HIGHLAND CITY PLANNING COMMISSION AGENDA

DATE: January 17, 2024
TO: Planning Commission
FROM: Jay Baughman, Assistant City Administrator / Community Development Director
SUBJECT: PUBLIC HEARING: Preliminary Plat – Foxwood Estates, Millhaven Homes
TYPE: LAND USE (ADMINISTRATIVE)

The Planning Commission will hold a public hearing to consider a request by Millhaven Homes for approval of a preliminary plat for a 20-lot subdivision in the R-1-40 Zone located generally at 10630 North 6400 West, in Highland. The Planning Commission will take appropriate action.

**FOXWOOD Estates - Lot 13**

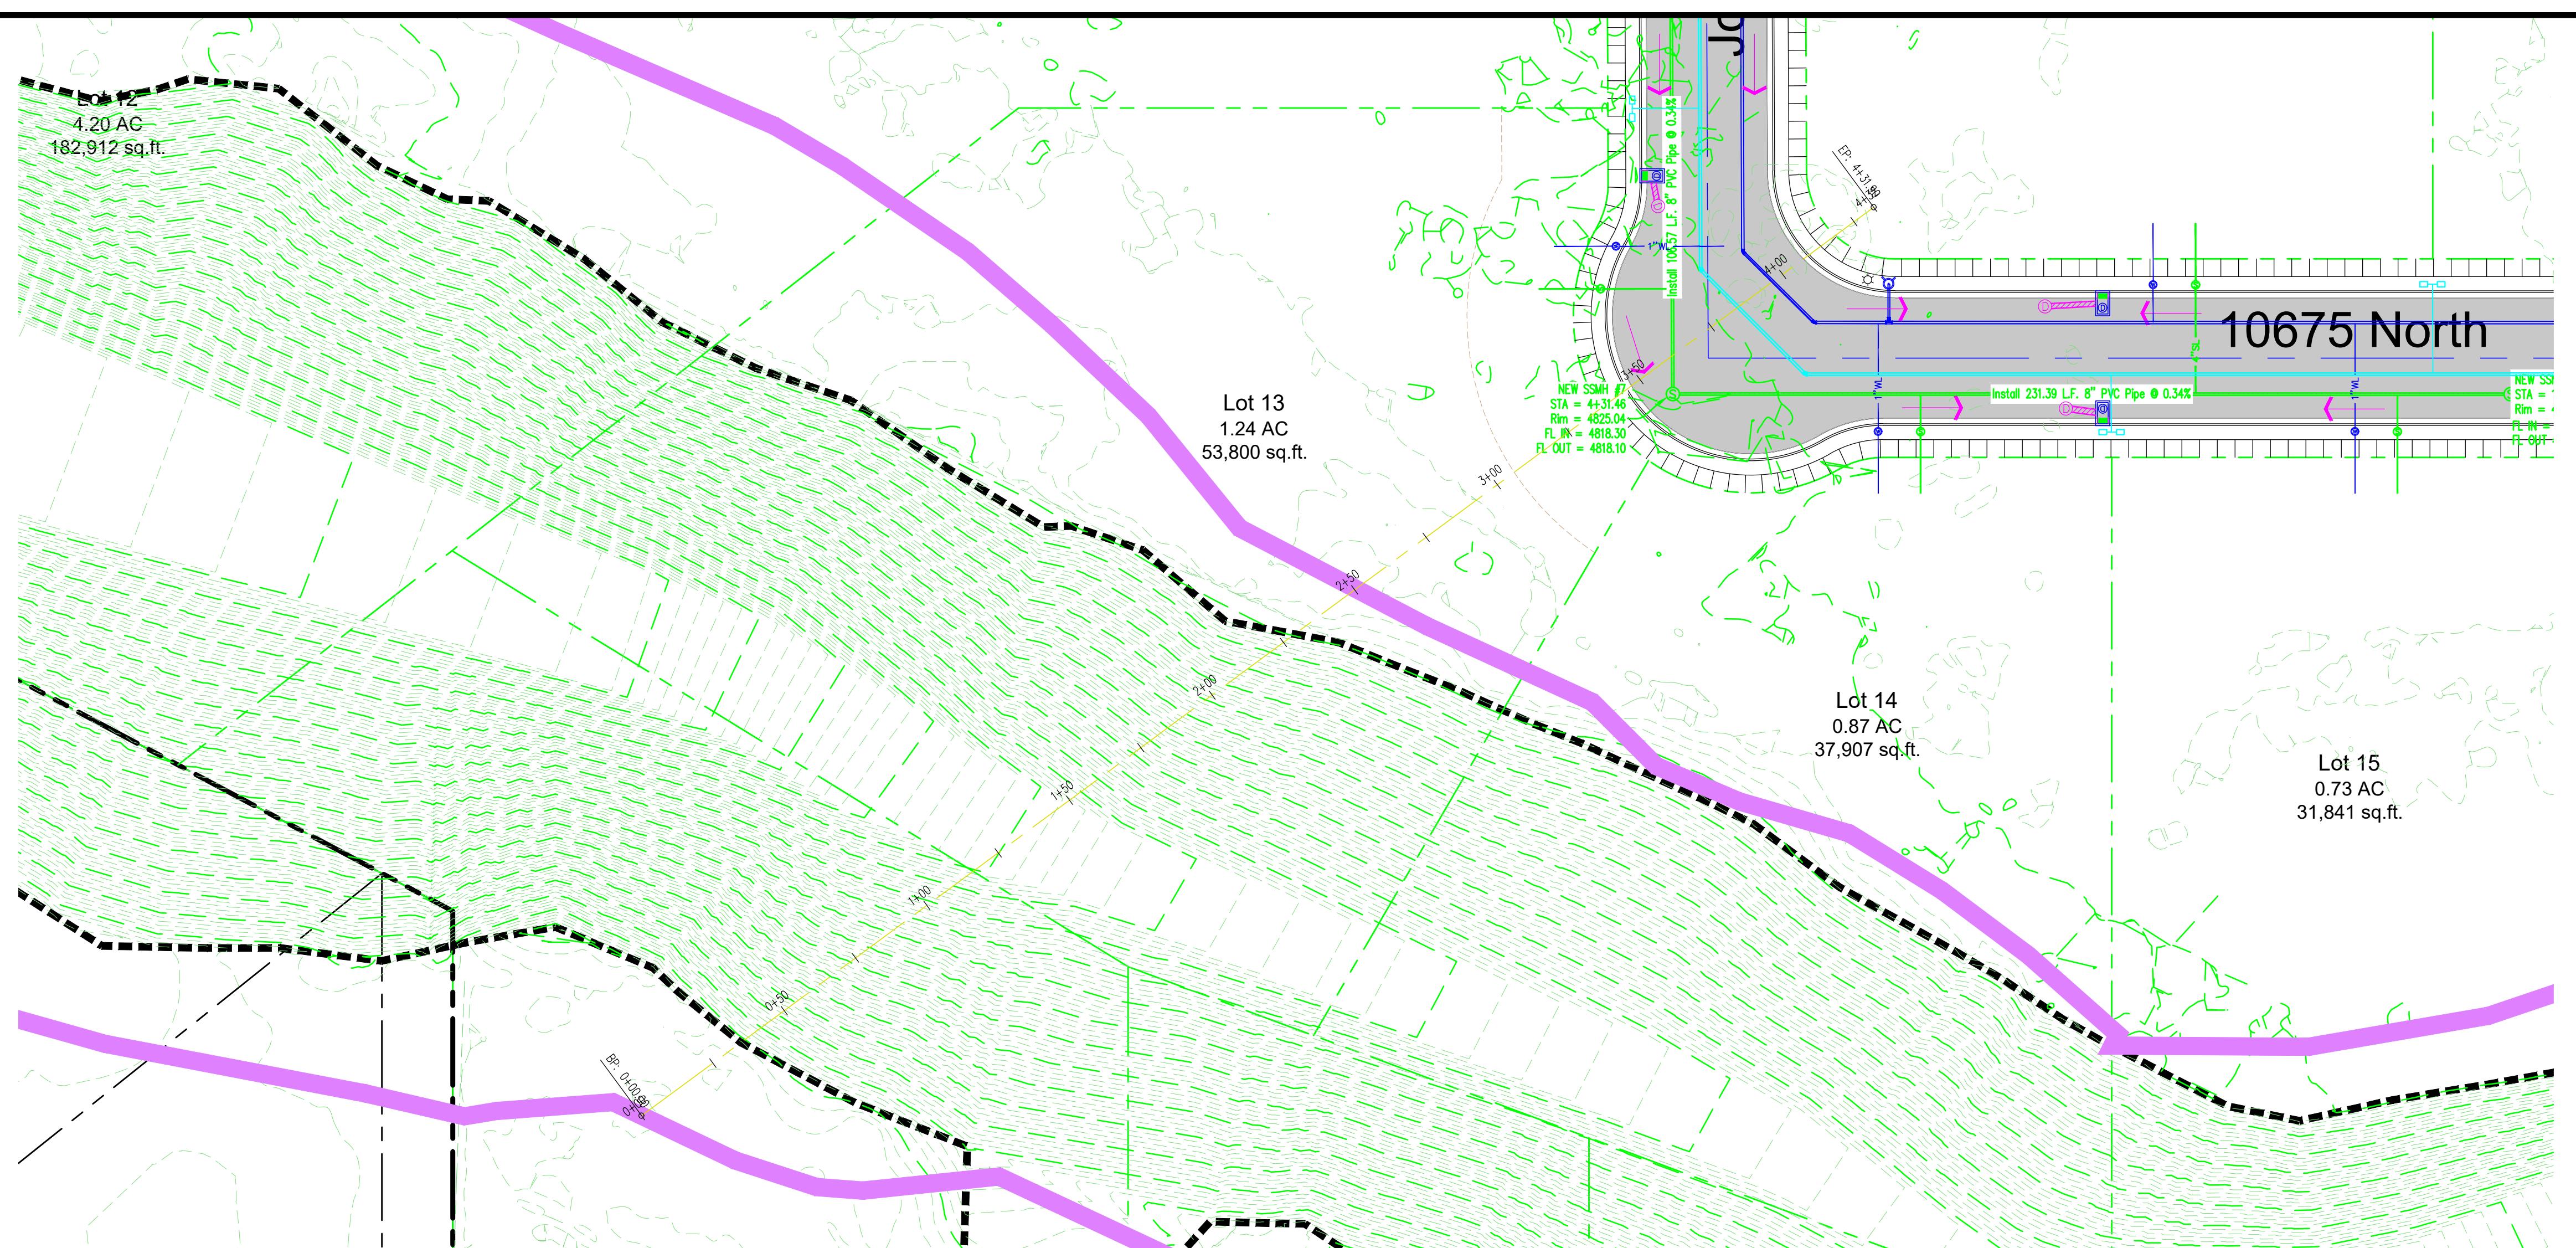
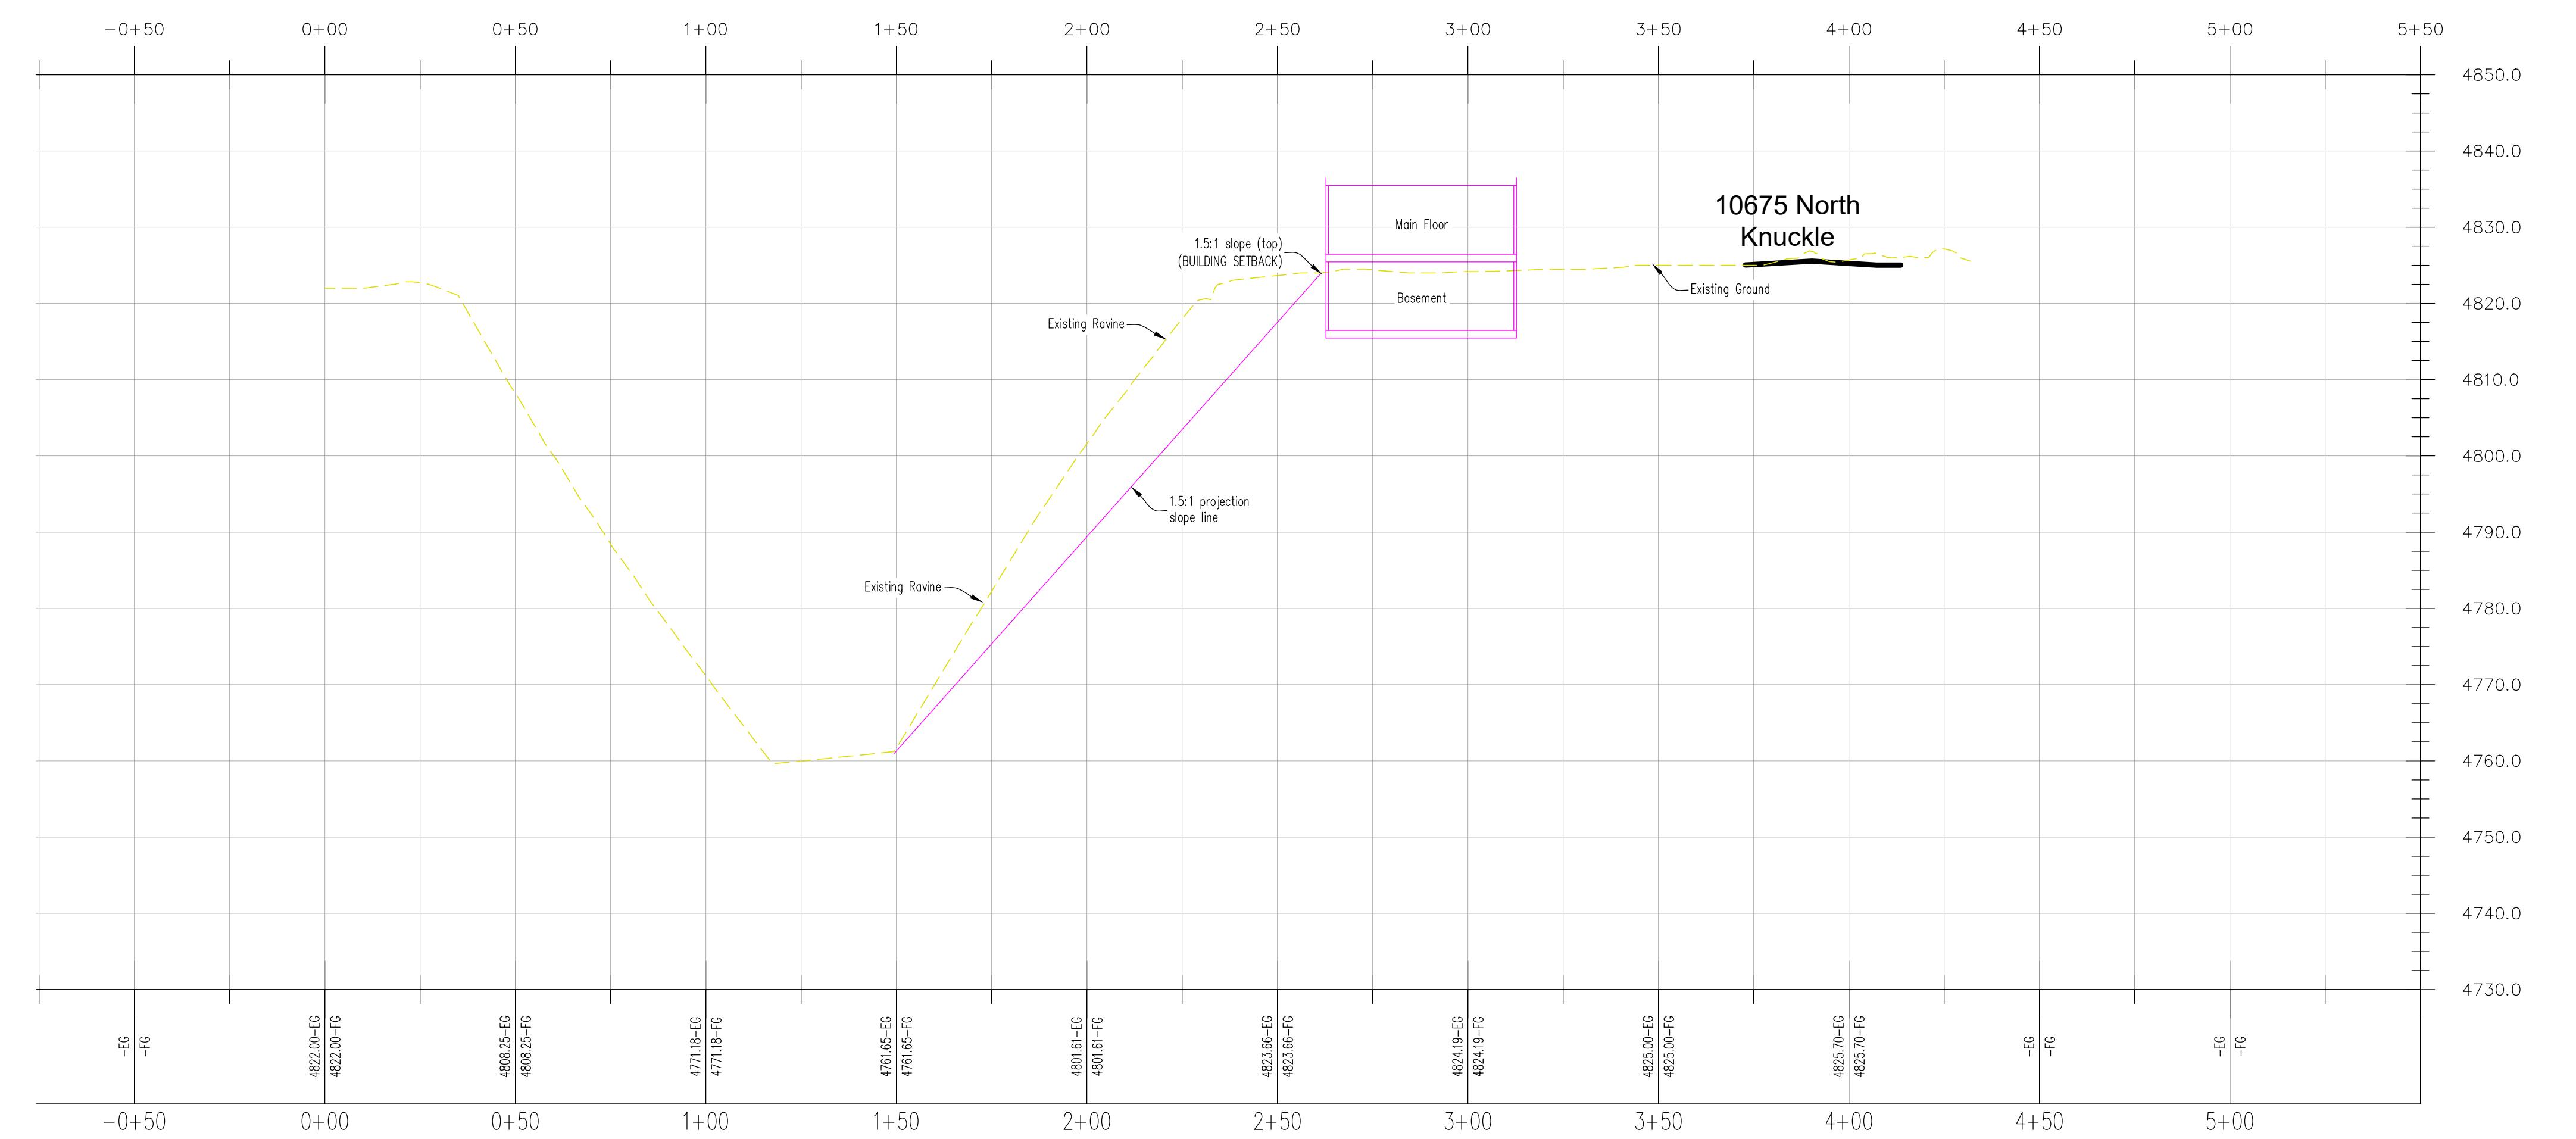
3. Frontages are unclear in lots 8 and 13, making it difficult to determine compliance with HDC 3-4103 130' frontage requirement. Confirm that Lot 20 has 130' frontage at front setback line.  
**Response: Frontage is on Lots 8,13 and 20 is shown and complies with the city code.**
4. Correct the alignment of Parcel A and B to the Highland City Sewer line and Lehi City water line easement(s) where they cross the hollow.  
**Response: This has been changed to follow the existing sewer line. Highland City will own the property with the sewer line.**

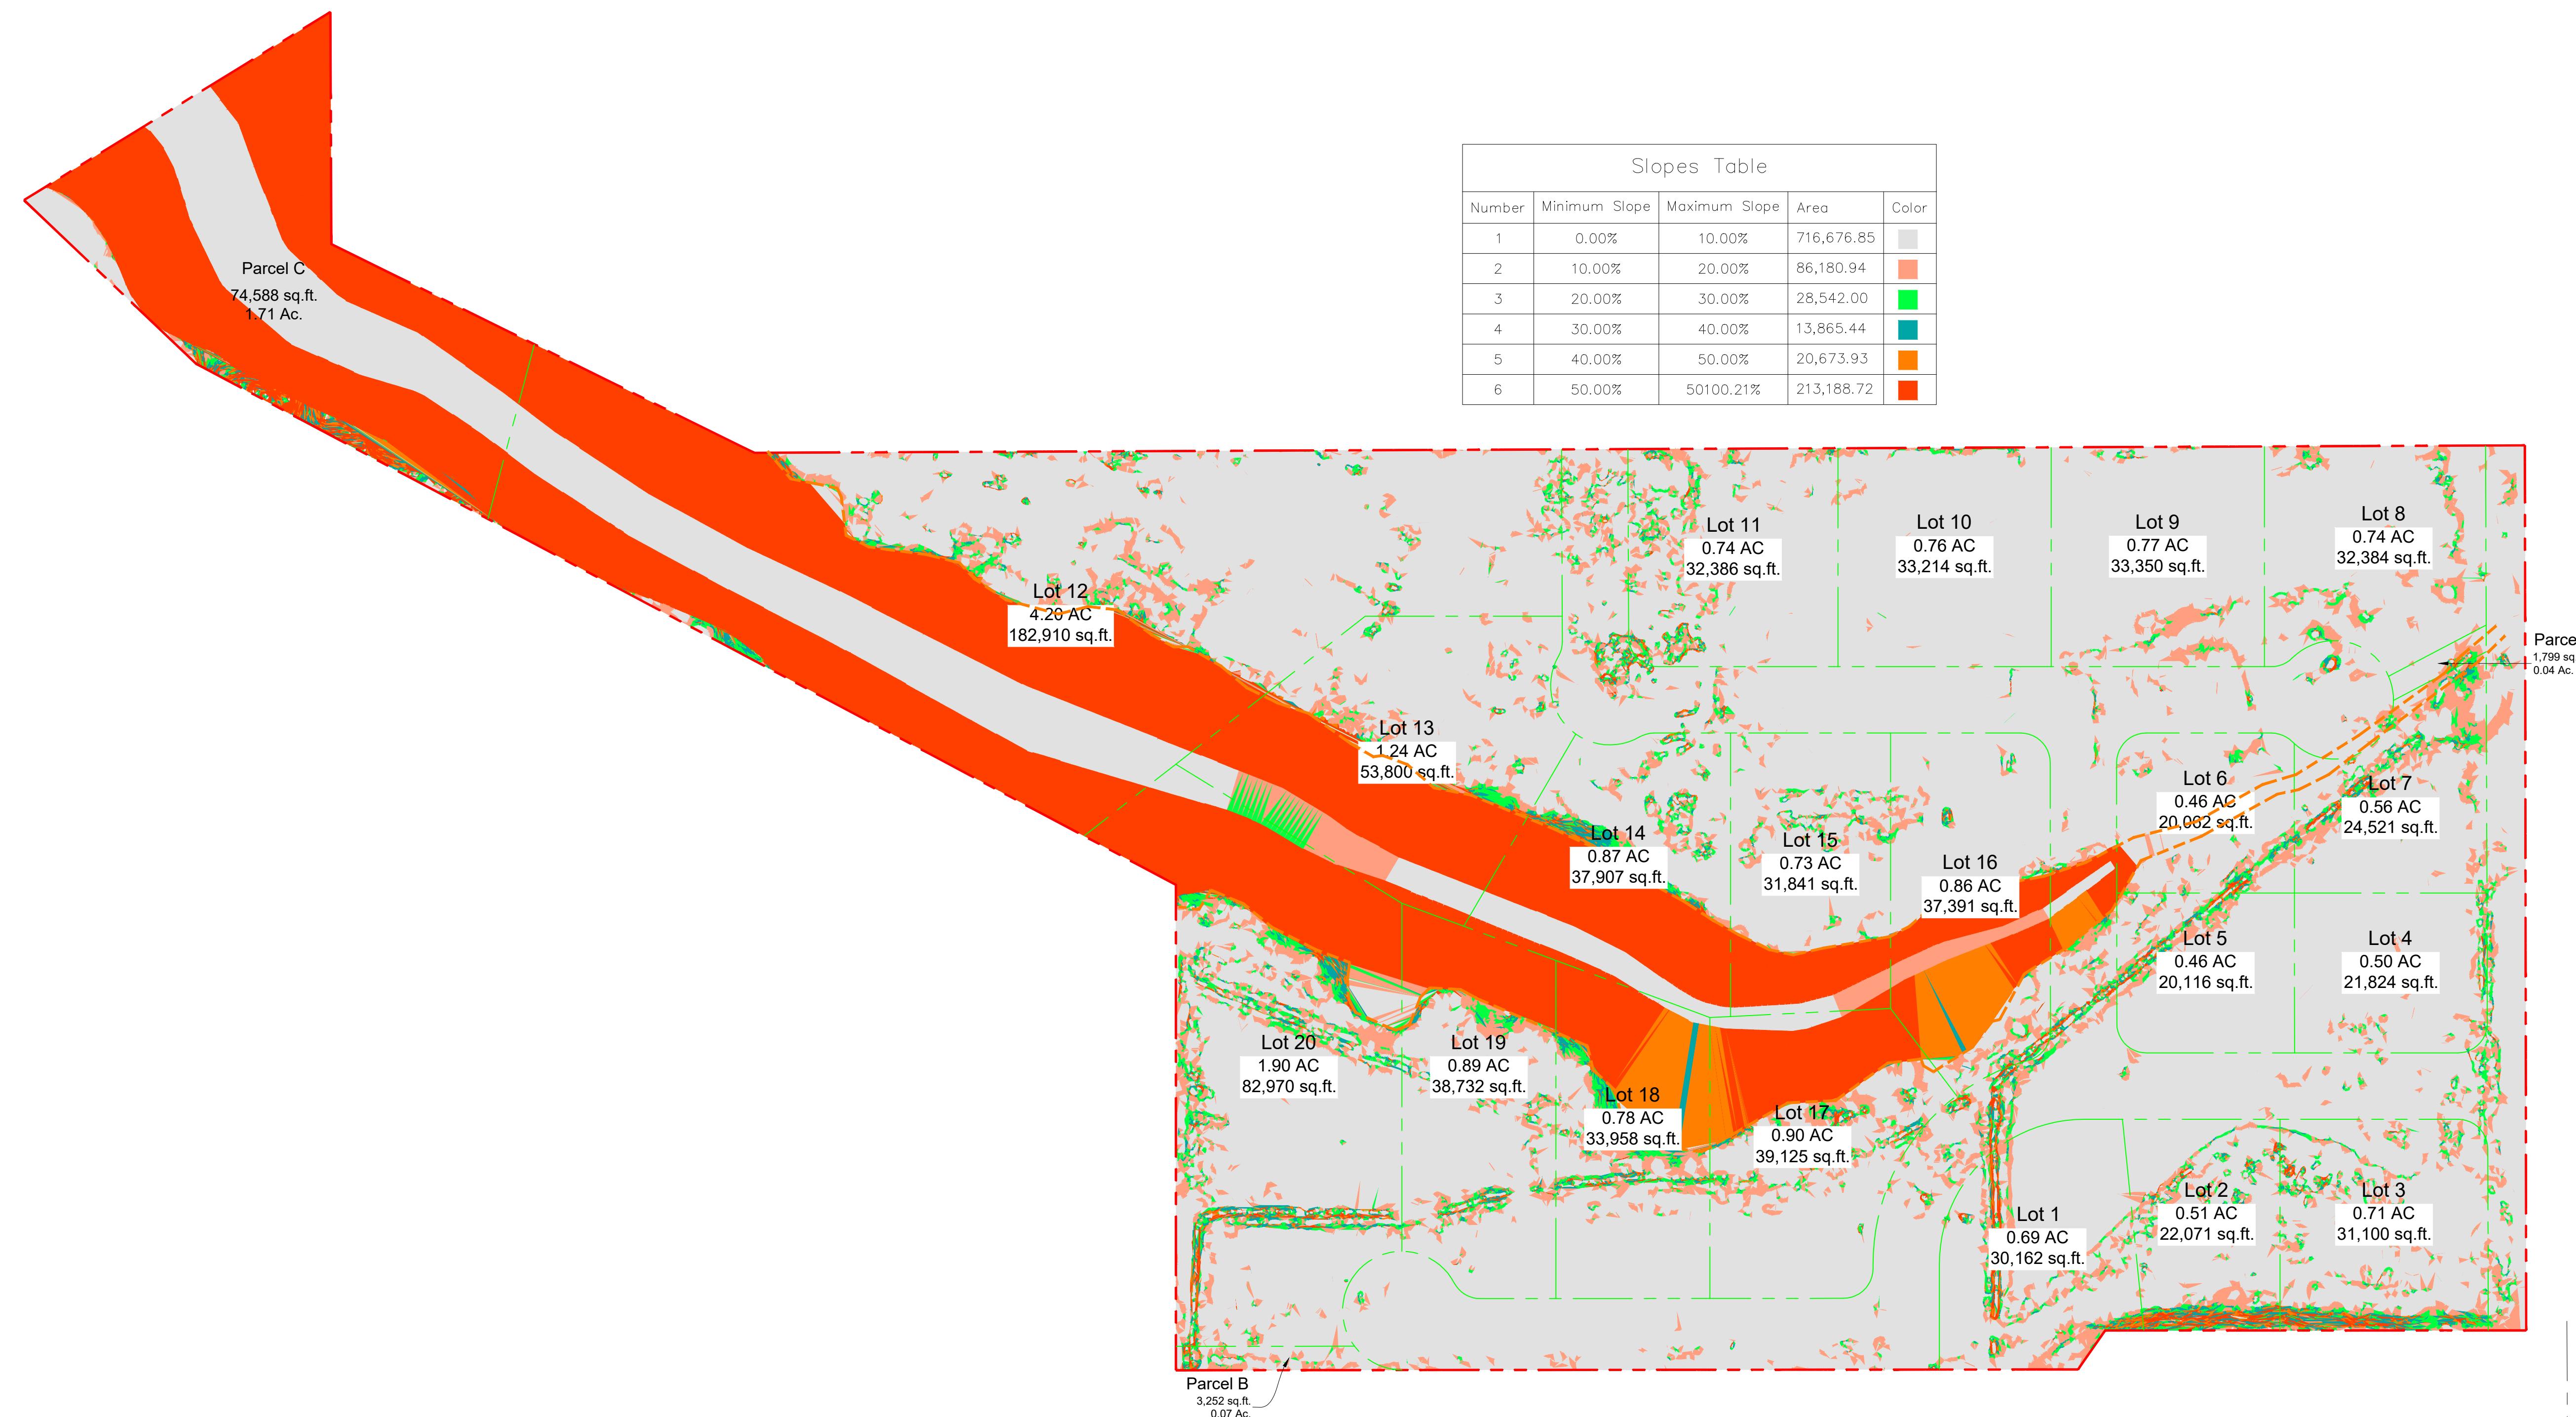
Applicant proposes to fill the easterly portion of the wash. It has been represented by the applicant that the wash in these areas is limited to less than 8-foot of fill.

The applicant has offered as evidence of the slope stability, the number of homes that have been built on the south side of the wash in the Canterbury subdivision. Based upon the geotechnical engineers' findings, staff does not oppose the applicants request, provided the suggested stipulations be incorporated into the requirements for approval and into the final subdivision

construction plans and home construction. The data provided by the applicant, including a drainage report (Roger Dudley PE, October 2023), geotechnical engineering study that contained a soil investigation report (CMT Technical Services, November 28, 2023), and a slope analysis (Dudley and Associates, November 8, 2023), and the mitigation and impact reduction efforts proposed by the applicant appear to satisfy the 6 conditions necessary to grant a variance to the slope setback per HCC 8-105(2)(a) - (f).

- The geotechnical engineer of record shall certify the fill placed in the wash/channel within lots 5, 6, 7, 8, 16, and the public roadway corridor. A note be added to the recorded plat indicating to owners of those lots that portions of the lot contain a filled natural wash area.

- Applicant shall provide grading validation (cross-sections) of the wash in the lots which are filled to ensure that fill is less than 8-foot as limited in the sensitive land ordinance. (HCC 8-107 1.)
